**TOWN OF NEWBURGH
PLANNING BOARD
TECHNICAL REVIEW COMMENTS**

PROJECT: LAKESIDE SENIOR HOUSING
PROJECT NO.: 2016-19
PROJECT LOCATION: SECTION 86, BLOCK 1, LOT 39.22 & 39.23
REVIEW DATE: 14 JULY 2017
MEETING DATE: 20 JULY 2017
PROJECT REPRESENTATIVE: MEDENBACH AND EGGERS

5 WATER QUALITY BASIN #1 OUTLET STRUCTURE

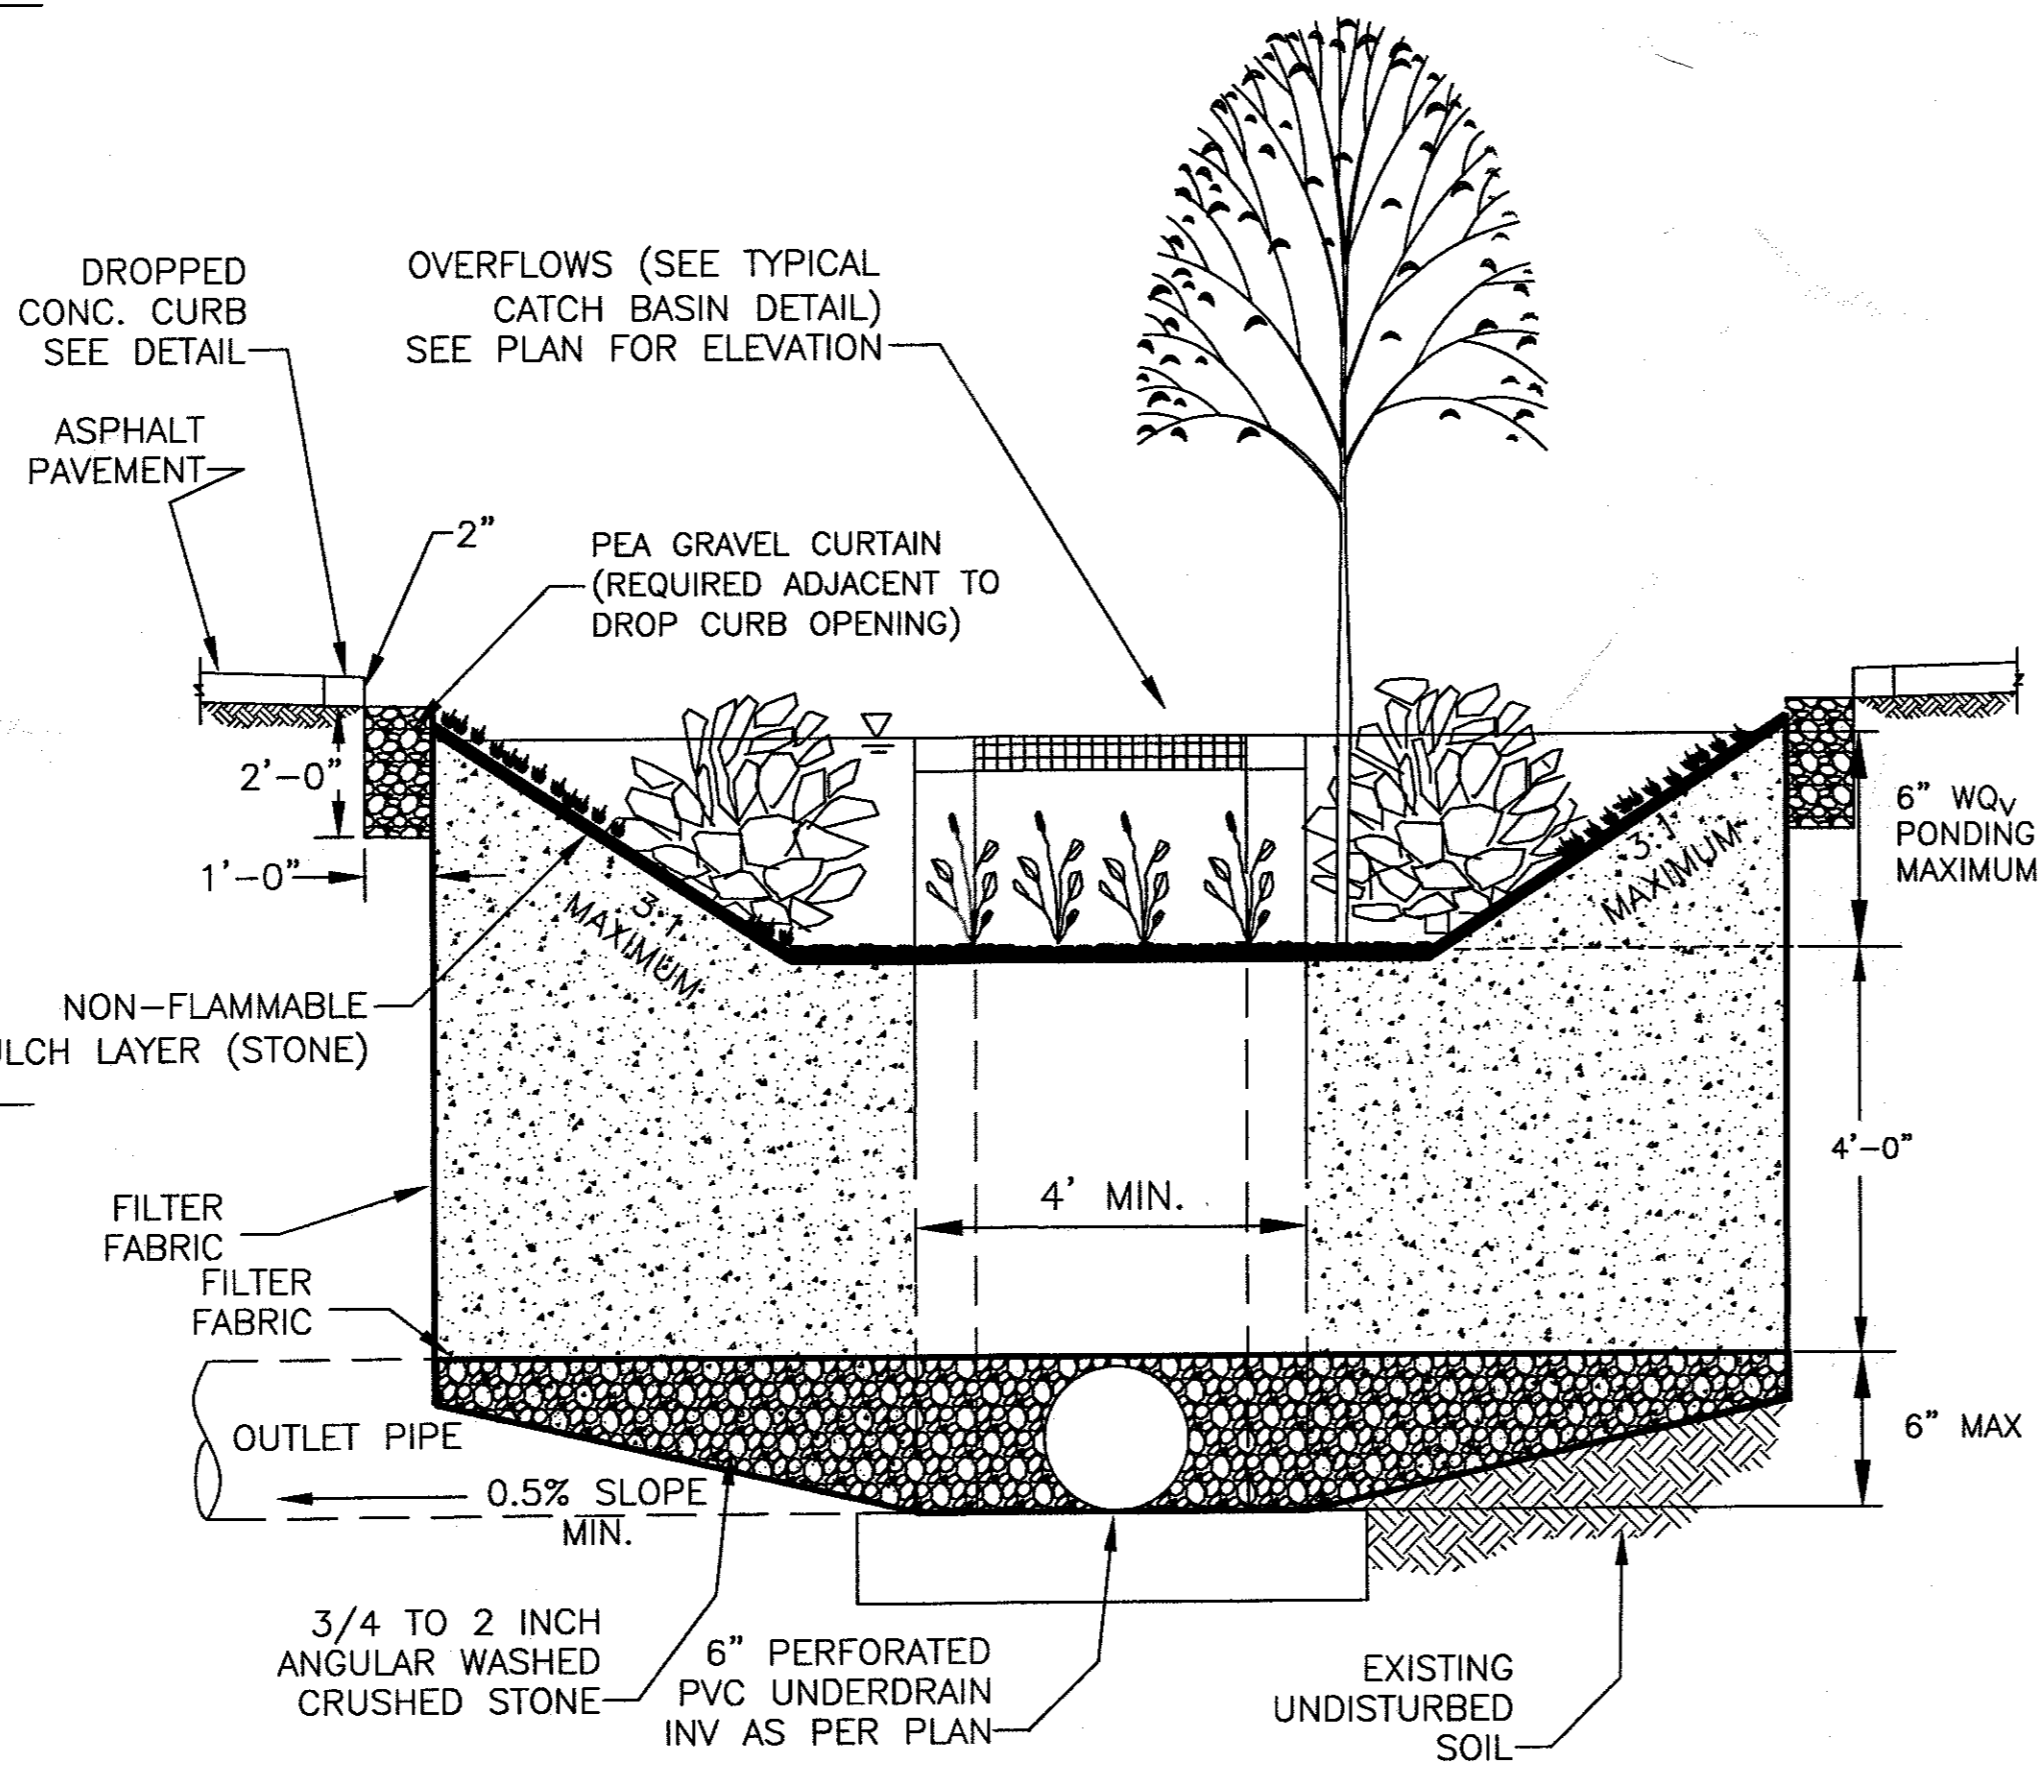
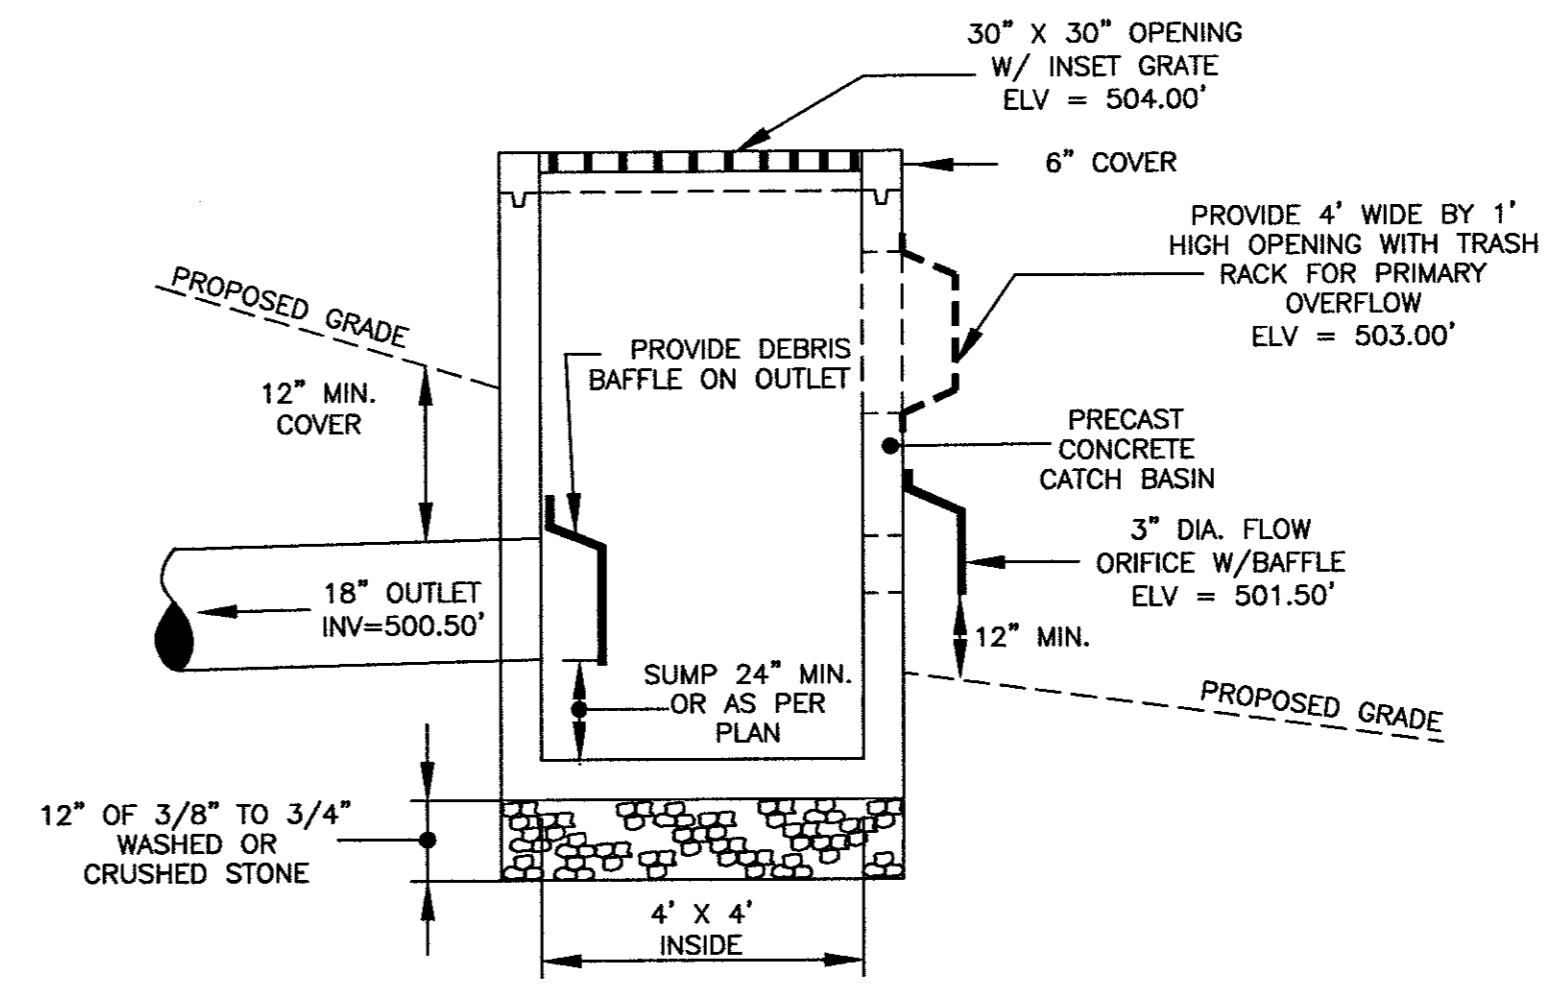
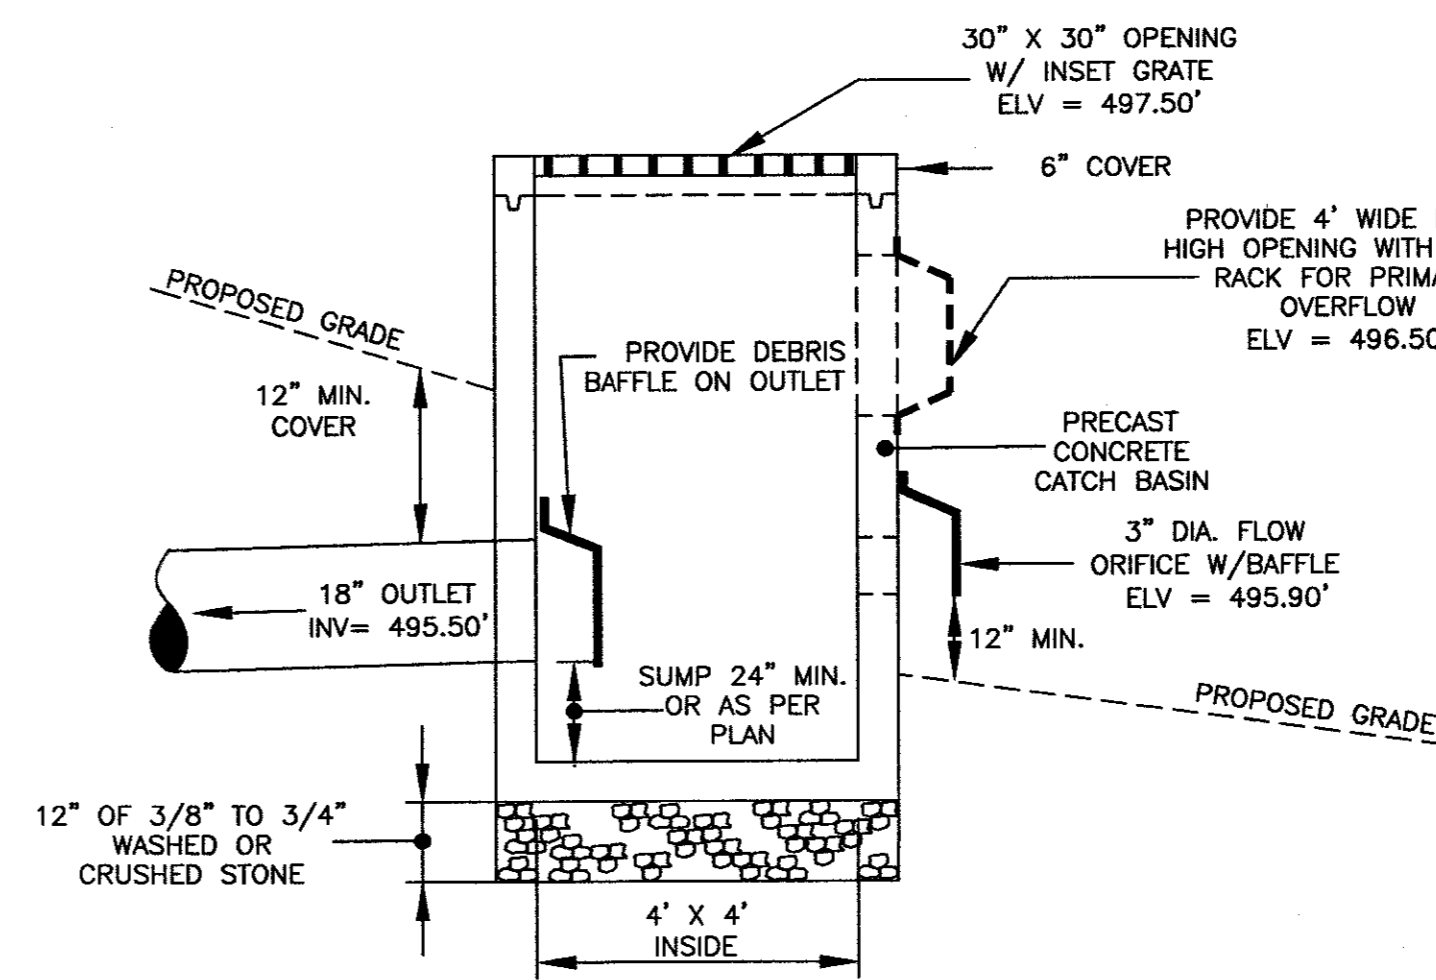
1. City of Newburgh Flow Acceptance letter was issued on March 27, 2017 and previously submitted.
2. Outlet control structure has been added to the plans
3. New York State Department of Environmental Conservation (NYSDEC) permit notice will be published July 7, 2017 – affidavit pending.
4. Architectural plans are attached.
5. Generator location has been revised.
6. Engineering Report for sanitary pump station has been completed and attached for your review.
7. Storm Water Pollution Prevention Plan (SWPPP) has been completed and attached.

MAP REVISION DATES		
DATE	REVISION	BY
03-27-2017	ADDED BIO SOIL CHARACTERISTICS CHART	SL
05-31-2017	ADDED WATER QUALITY BASIN OUTLET STRUCTURE DETAILS	CC
